# Modification Recommended Service Note

## N8935A - Autoranging System DC Power Supply, 750V, 60A, 15000W, 208 VAC

Serial Numbers: DE14290000 - DE15369999 without manufacturing ID Version "B"

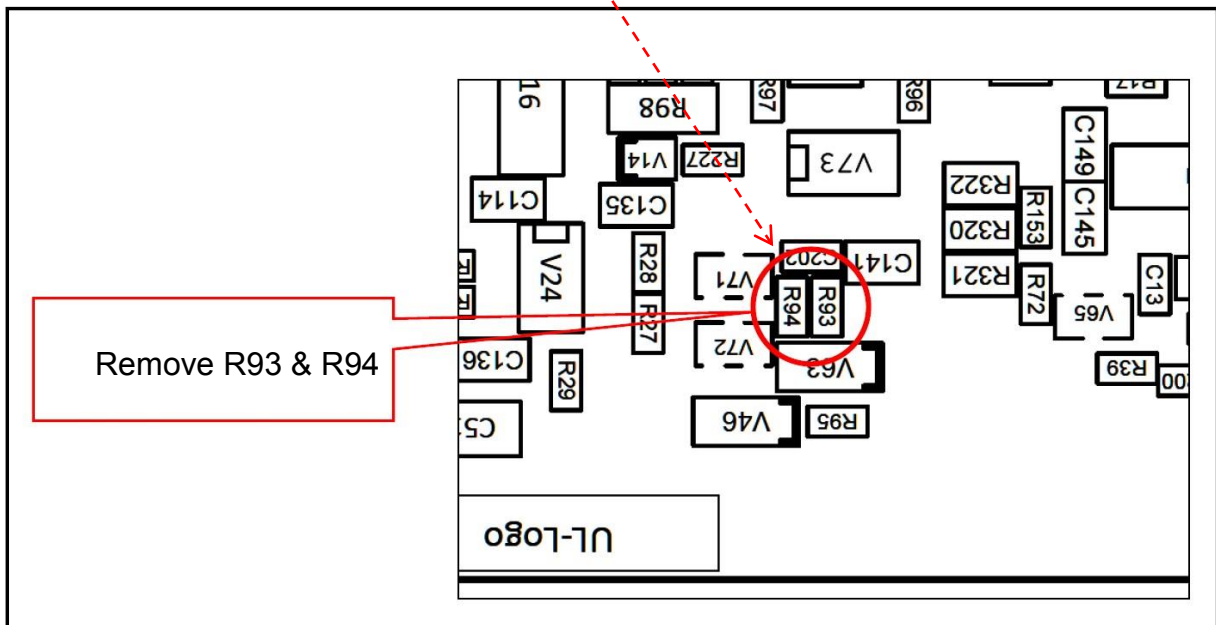
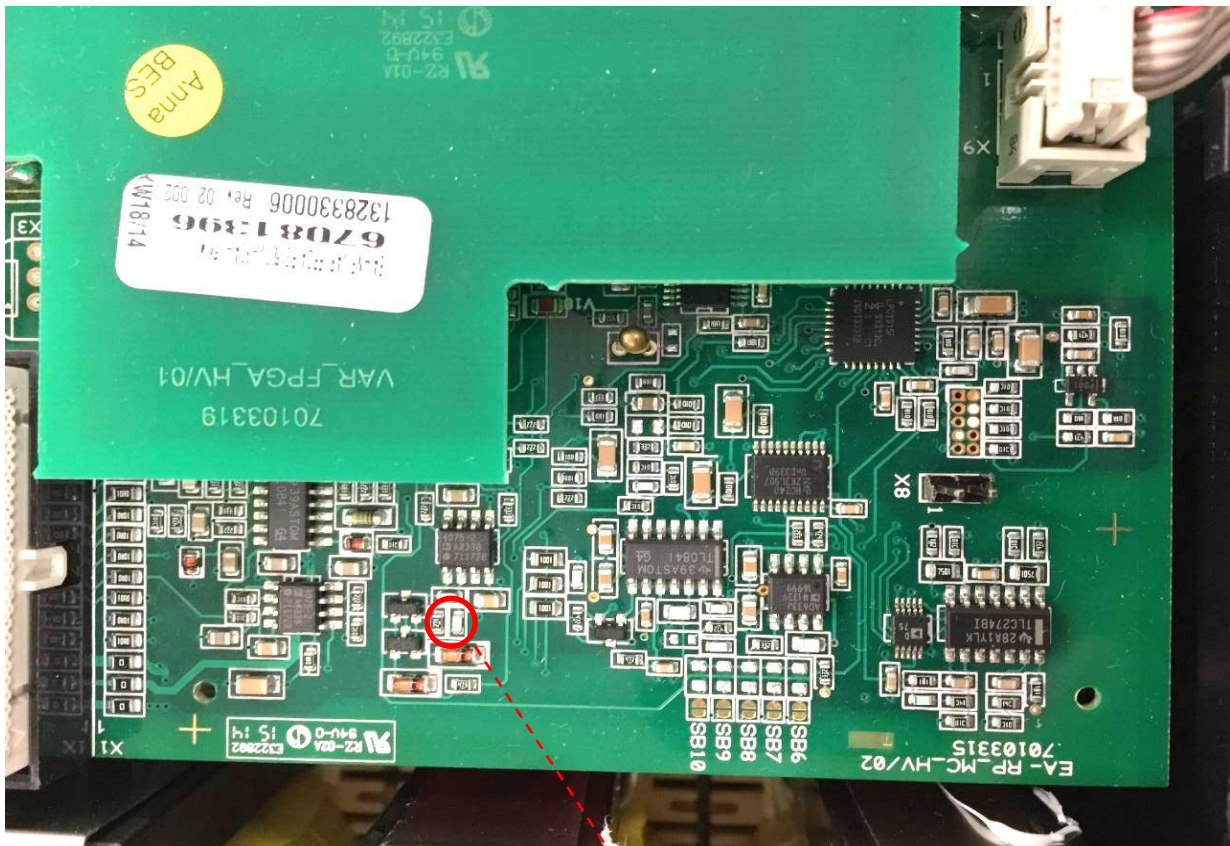
- 1) Remove acMains cable from power source.
- 2) Wait 5 minutes
- 3) Remove top cover from instrument.
- 4) In the 5kW units (viewed from the front of the unit), a small SMT assembly located at the right-rear of instrument will be readily visible (see below):

In the 10kW & 15kW units; although found in the same location, a black plastic cover will have to be removed to gain visibility and access to the SMT assembly. Plastic cover snaps-on and can be removed with a small screwdriver.

Removal of two (2) surface mount resistors, R93 and R94, will correct this problem:

Suffix "B" added

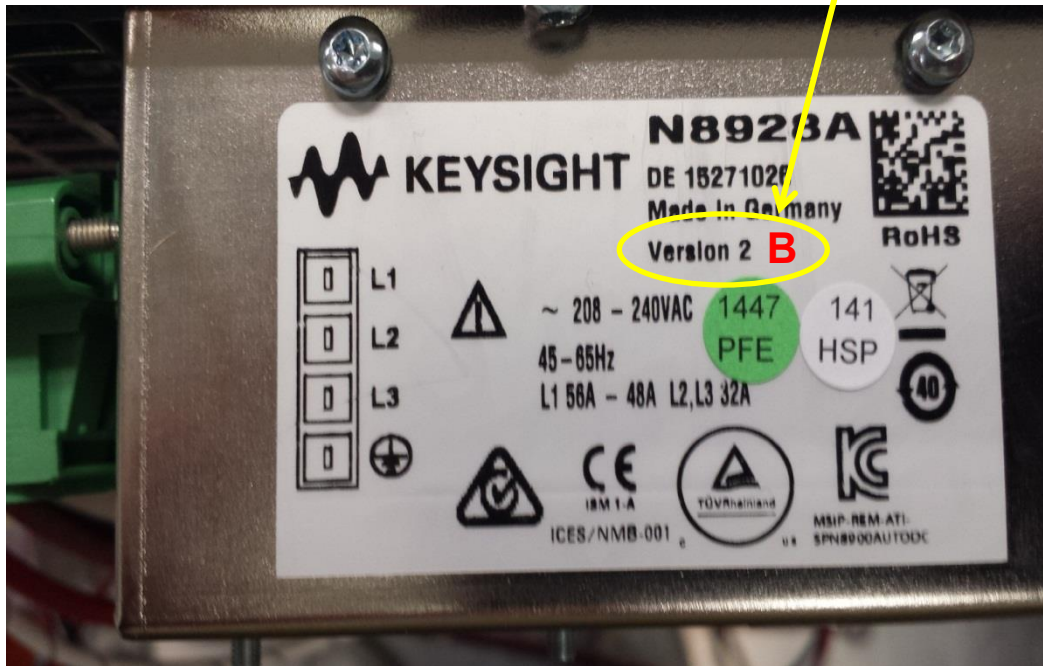
7) On the acMains label, on the rear of the instrument; use an indelible marker, to add the suffix letter "B" after the Version ID. This will assist in the tracking of modified instruments.
